CRWA
Saving the Charles River since 1965

Re: Draft Massachusetts MS4 Permit

Charles River Watershed Association (CRWA) has reviewed the draft Small Municipal Separate Storm Sewer System (MS4) National Pollutant Discharge Elimination System (NPDES) general permit for Massachusetts (draft permit). CRWA, a research and advocacy organization formed in 1965, works extensively on stormwater pollution issues, and we have conducted research and modeling on phosphorus pollution in the Charles River; undertaken wet weather end-of-pipe and receiving water monitoring programs; and designed and constructed stormwater improvement projects. We work in partnership with agencies, municipalities and organizations across Massachusetts.

SEWAGE INFRASTRUCTURE IN THE CHARLES RIVER WATERSHED

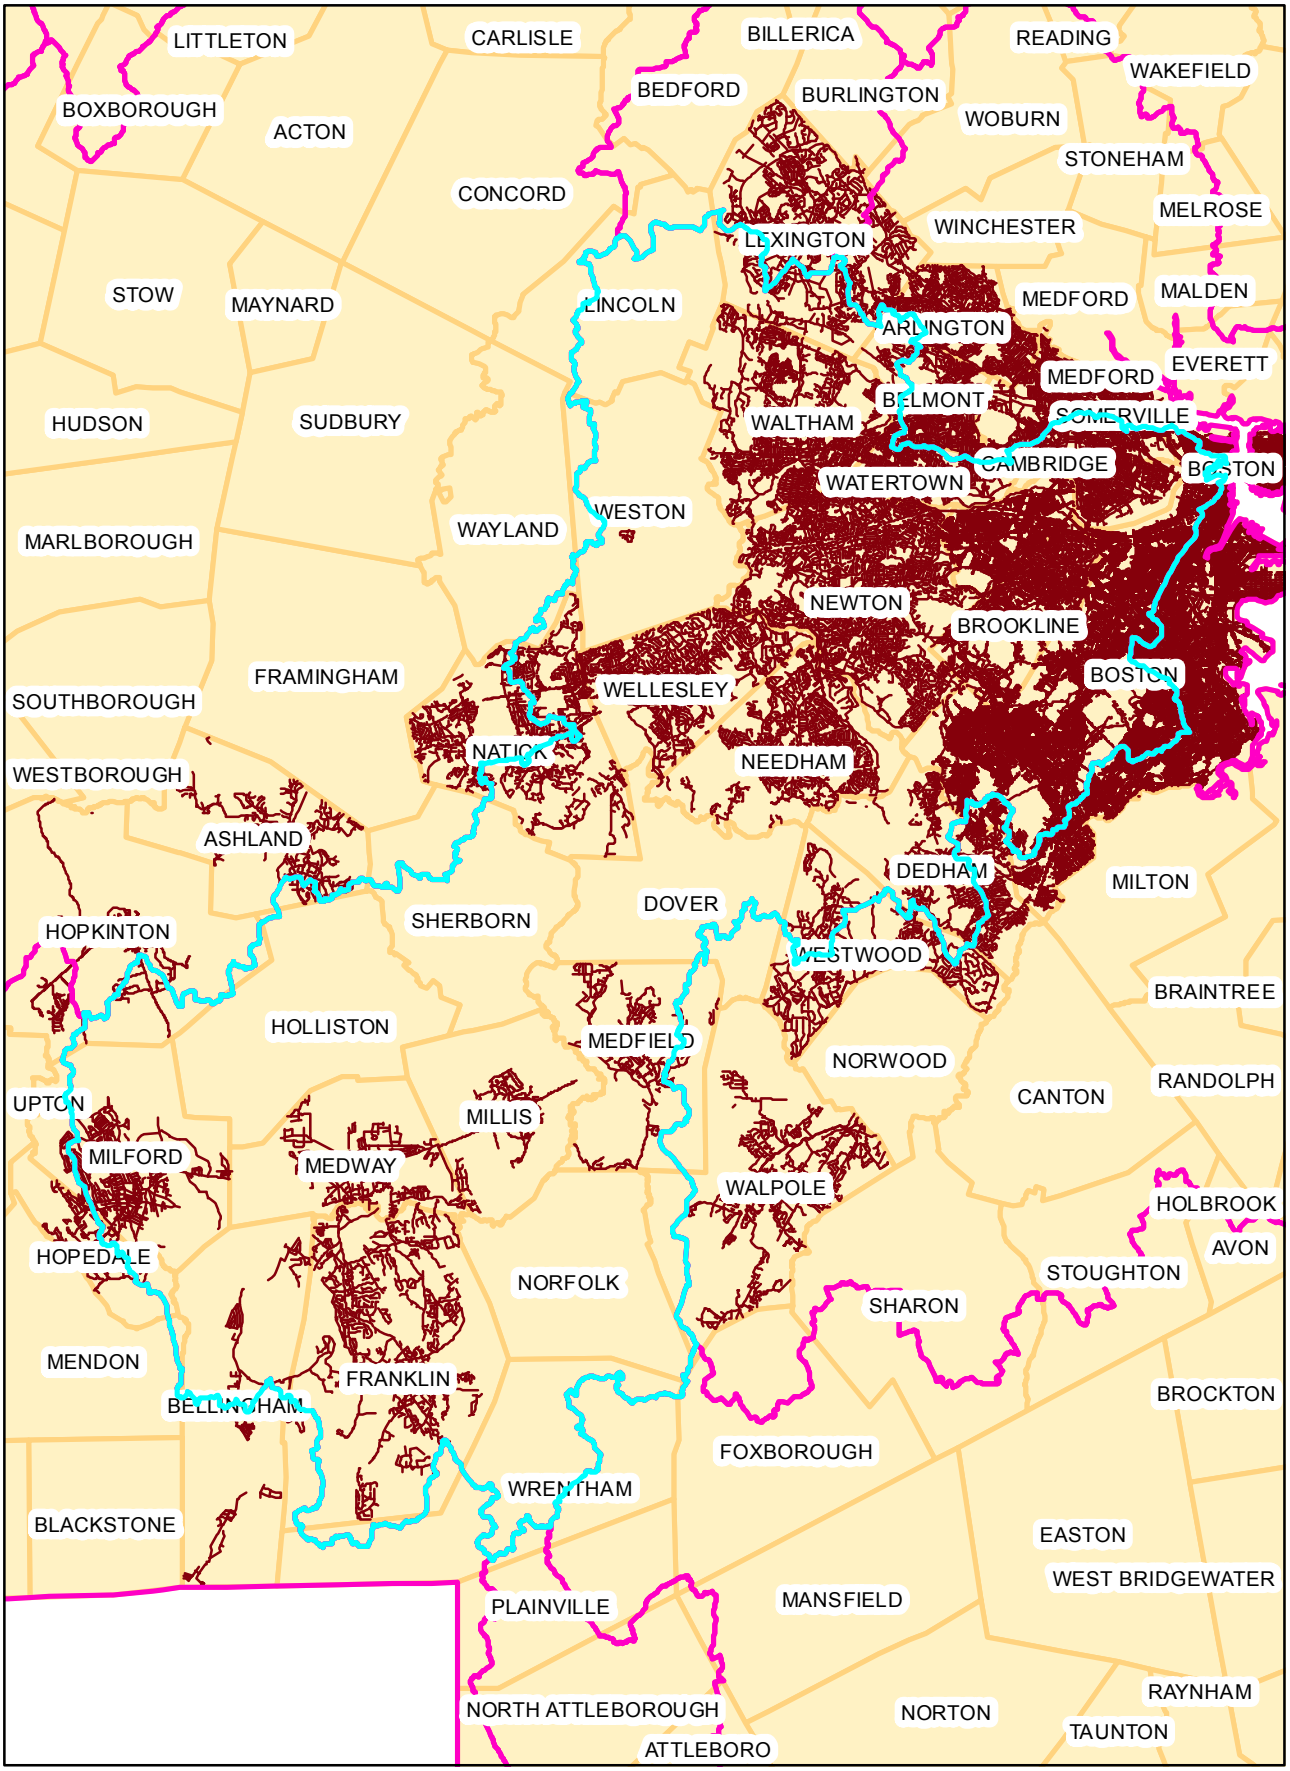
Notably, as the map attached to our comments shows, Dover, Holliston, Mendon, Norfolk, Sherborn, Wayland, Weston and Wrentham are entirely on septic; and Bellingham and Millis have little sewage infrastructure. Yet the default phosphorus load reduction for IDDE work in Table 15 is applied to each of them. This is erroneous.

CRWA believes that in the case of a general permit, where highly detailed site specific data is not being used to establish permit requirements, this is inappropriate. At a minimum, the reduction should be limited to no more than five percent and then only applicable in those communities with the potential to have a high number of illicit connections/discharges.
